HISTORIC AND DESIGN REVIEW COMMISSION

February 07, 2018

HDRC CASE NO: 2018-060
ADDRESS: 211 W HOLLYWOOD AVE
LEGAL DESCRIPTION: NCB 6459 BLK 10 LOT 12, 13, 14, 15, 16, 17 & W 18 FT OF 18
ZONING: R-5 H
CITY COUNCIL DIST.: 1
DISTRICT: Monte Vista Historic District
APPLICANT: Jozsef Terenyi and Zsuzsanna Maros
OWNER: Jozsef Terenyi and Zsuzsanna Maros
TYPE OF WORK: Conceptual review of proposed lot division and site plan for new construction
APPLICATION RECEIVED: January 18, 2018
60-DAY REVIEW: March 19, 2018
REQUEST:

The applicant is requesting conceptual approval of a site plan. The proposed plan will subdivide the existing lot addressed 211 W Hollywood Ave and include new construction of a primary single family residential structure, rear accessory structure, and site elements.

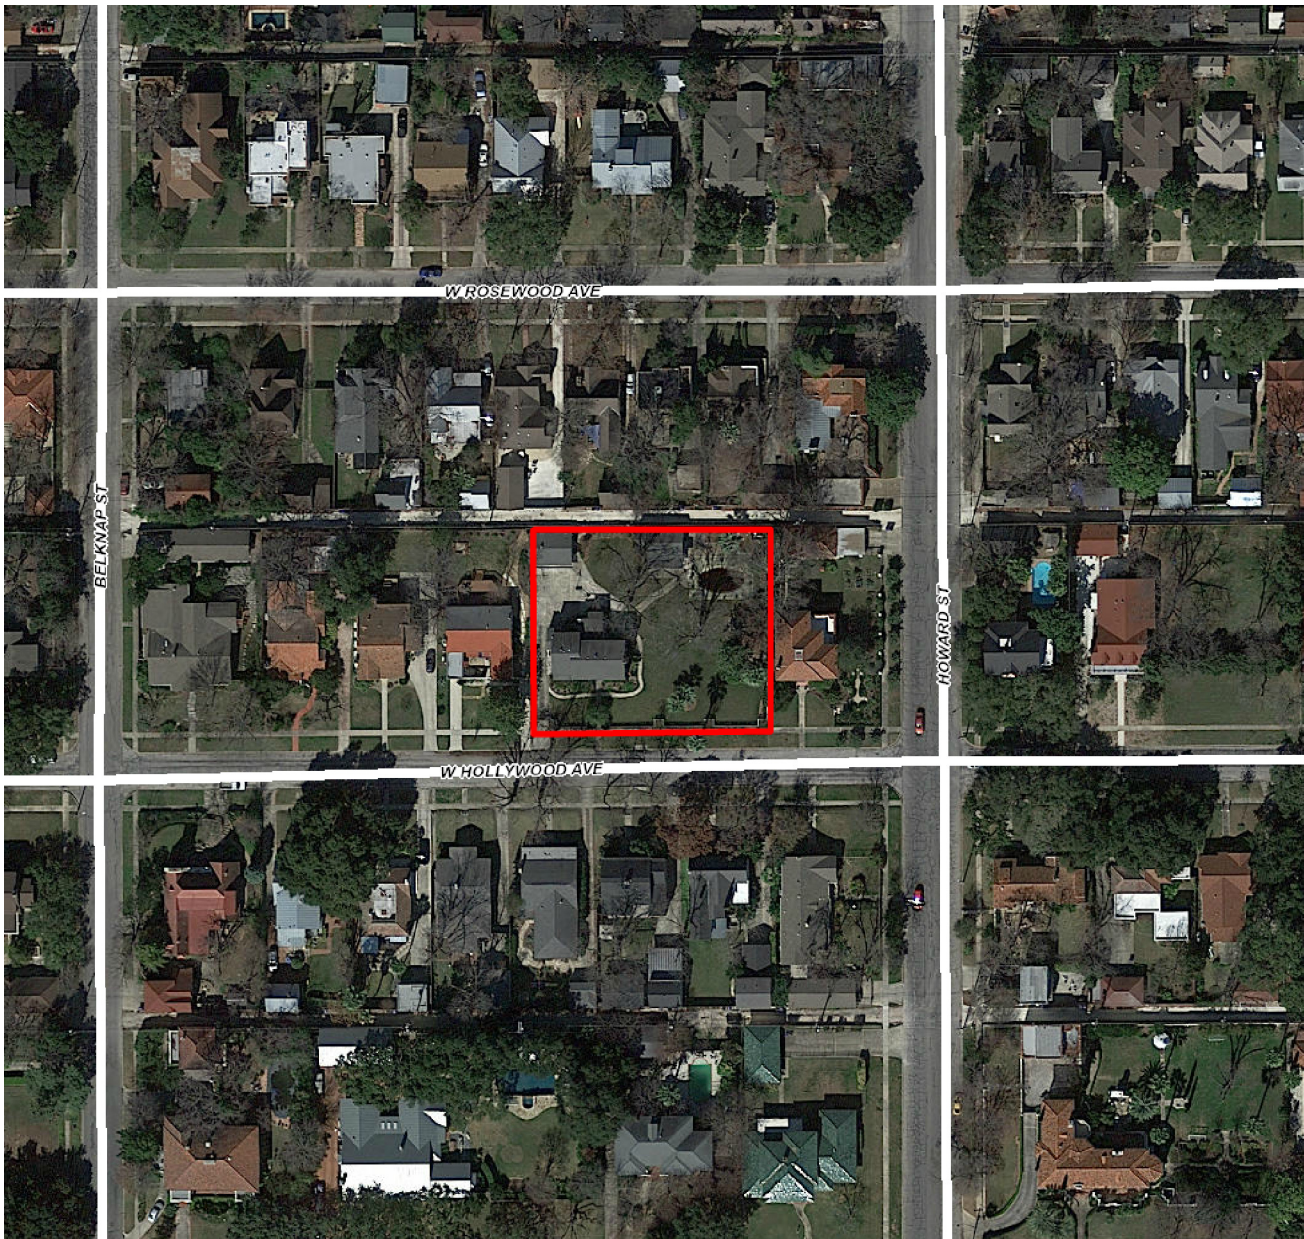
- d. FOOTPRINT – The proposed lot division will create a new lot to the east of 211 W Hollywood Ave. The new lot will measure 167 feet by 56 feet for a total of 0.2147 acres. Per the submitted conceptual site plan, the proposed primary structure will feature a rectangular footprint spanning nearly the full width of the new lot. According to the Historic Design Guidelines, new construction should respond to the existing development pattern of the district. While the proposed primary structure closely matches the footprint of the primary structure at 211 W Hollywood Ave, the footprint is very close to the proposed side lot lines. Historic structures in the district do not feature footprints that span the entirety of the width of the lot. Staff recommends that the width of the structure be reduced to be more consistent with historic development patterns and lot relationships, as well as modern zoning setback requirements, which require a setback of a minimum of 5 feet from all lot lines.

- e. FRONT SETBACK – The applicant has proposed to closely match the existing front setback of the primary structure at 211 W Hollywood Ave. According to the Historic Design Guidelines, setbacks for new construction should respond to the predominant setback established on the block by contributing historic structures. Staff finds that the new structure should be set back slightly from the existing nearby historic structures to comply with the Guidelines.

- f. LOT COVERAGE – According to the Historic Design Guidelines, new construction should be consistent with adjacent historic buildings in terms of the building to lot ratio. The building footprint for new construction should be limited to no more than 50 percent of the total lot area. The proposed site elements, including a primary structure, rear garage, and pool, do not total 50% lot coverage. Staff finds the proposal generally consistent with the level of information provided at this time.

- h. **TREE REMOVAL** – The proposal will require the removal of two palm trees, one magnolia, and one mature tree. Several other mature trees will be retained. According to the Historic Design Guidelines for Site Elements, mature and heritage trees should be preserved. The applicant is required to coordinate with the City Arborist's office to determine the significance of the trees to be removed. Staff encourages the applicant to explore all design solutions that can potentially retain existing mature trees, including modifying the proposed footprint and incorporating any mature trees into the overall design of the home.

- i. **NEW REAR ACCESSORY STRUCTURE** – The proposal includes a new rear accessory structure. According to the Historic Design Guidelines, new garages and outbuildings should be visually subordinate to the principal historic structure in terms of their height, massing, and form. New garages should also follow established setback and orientation patterns in the district. There is an established development pattern of garages placed close to the rear lot lines and accessible from the rear alley. Staff finds the proposal conceptually consistent with the information provided. The applicant will be required to obtain a variance if this location is pursued for final approval.

- j. **DRIVEWAY AND PARKING** – The applicant has proposed to utilize an existing concrete slab in the rear of the lot for parking and garage access. The parking will be accessed from a rear alley. As noted in finding i, this is a common precedent in the historic district and nearby houses. Staff finds the proposal consistent.

- i. That the applicant reduces the width of the primary structure as noted in finding d.
- ii. That the applicant increases the front setback of the primary structure as noted in finding e. The applicant is required to submit a setback analysis of nearby structures on the street in their future HDRC submittals.
- iii. That the applicant coordinates with the City Arborist's office to determine the significance of the trees to be removed.
- iv. That the applicant explores all design solutions that can potentially retain existing mature trees, including modifying the proposed footprint and incorporating any mature trees into the overall design of the home. If this is not feasible, additional HDRC submissions should clearly illustrate why mature trees are unable to be preserved.
